TECHNICAL**BULLETIN****TECHNICAL BULLETIN: 11-01****DATE:** March 11, 2011**SUBJECT:** Introduction of new Electronic Lock on Business Hours Cabinets**AVAILABILITY:** All Authorized Triton Distributors and Third Party Service Providers

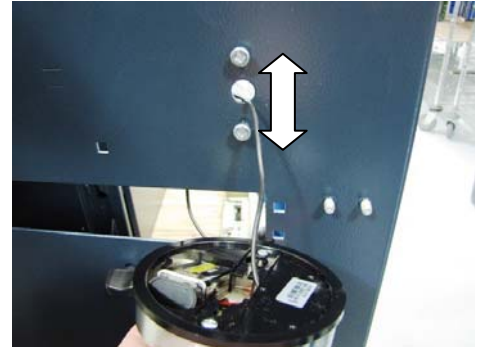
Triton announces the introduction of a new electronic lock for all business hours cabinets, referred to as the Swing Bolt. This lock is not applicable for the Level 1 vaults.

After entering the correct combination, the bolt will retract electrically, it is not necessary to turn the dial.

Use the door latching device to open the door.
